**CARLTON AND UNITED BREWERIES
CONCEPT PLAN - A SUBMISSION BY
THE CITY OF SYDNEY**

A Submission by the Council of the City of Sydney

November 2006

Figure 1: The Maltings, part of the Carlton Street Brewery Group

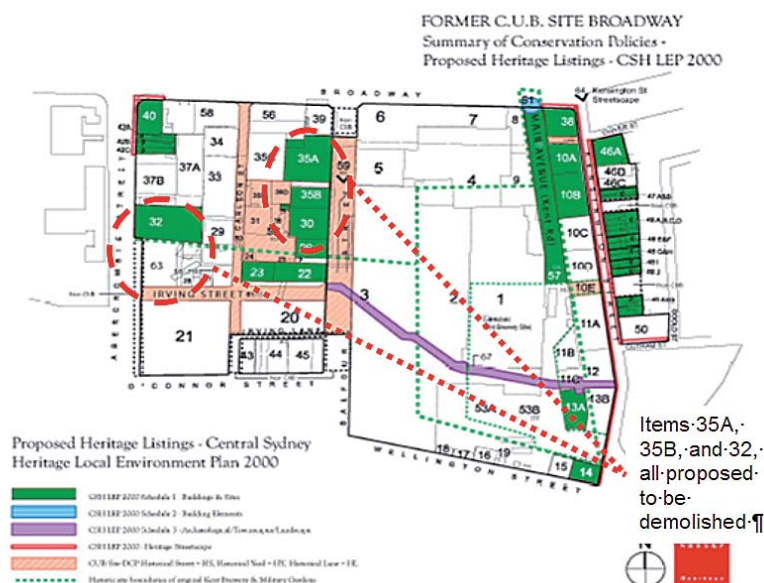
The CUB site contains some of Sydney's most significant industrial heritage buildings and elements. After a long process the site's owner, in late 2004 completed a heritage Conservation Management Plan (CMP) for the site. Unfortunately the concept plan as submitted is not consistent with the CMP, with Tooth Avenue requiring the removal of buildings 35A and 35B which are an extension of the Irving Street Brewery Complex (See Figure 2 below). Building 35C which the City contends is significant would also be removed. The concept plan would also lead to the removal of building 32, identified as significant for its use of pioneering construction methods, including the 'honeycomb' system illustrated below (Figure 1).

Figure 4: Street Layout proposed by the Draft DCP

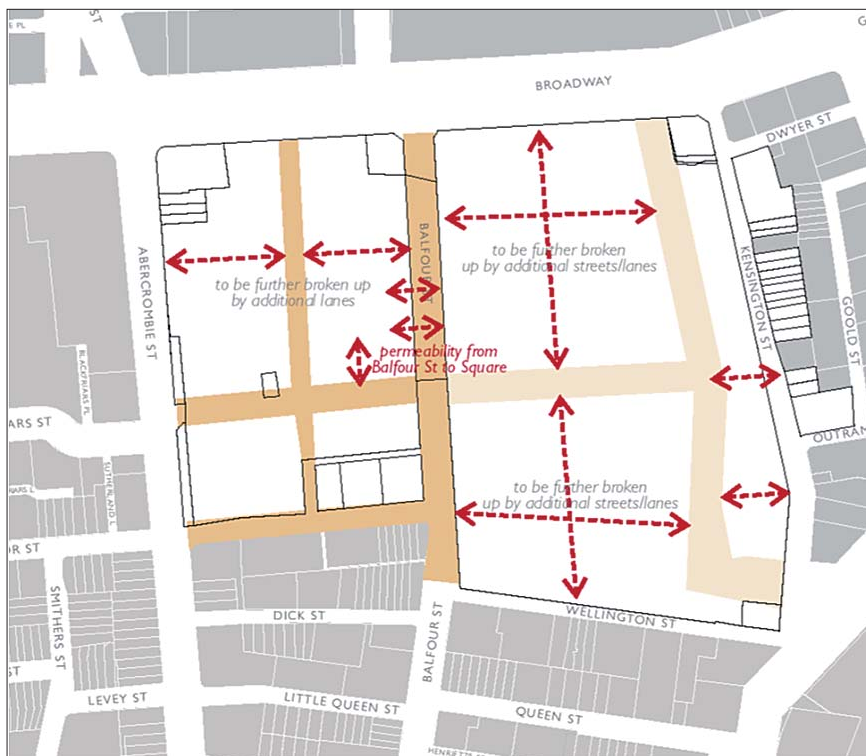
Of particular concern to the City is the street layout put forward by the concept plan. While being partly based on the existing heritage grid, the concept plan introduces a new street "Tooth Avenue". Figure 4 contains the City's preferred layout. The inclusion of the street raises a number of significant issues including:

- the street is an east west street which is surrounded by tall buildings. This means that it will not receive adequate solar access and is likely to have a dark and enclosed 'feel', particularly in Winter;
- the street width proposed for Tooth Avenue (being 20m) is excessive and out of keeping with the nature of the site and streets in Chippendale;
- Tooth Avenue would require the removal of significant buildings that are identified as having heritage significance; and
- Tooth Avenue does not link with any other areas and therefore will have difficulty in becoming a high street as envisioned by the proponents. A more natural street for this function is Balfour Street which links the site to Broadway and Chippendale.
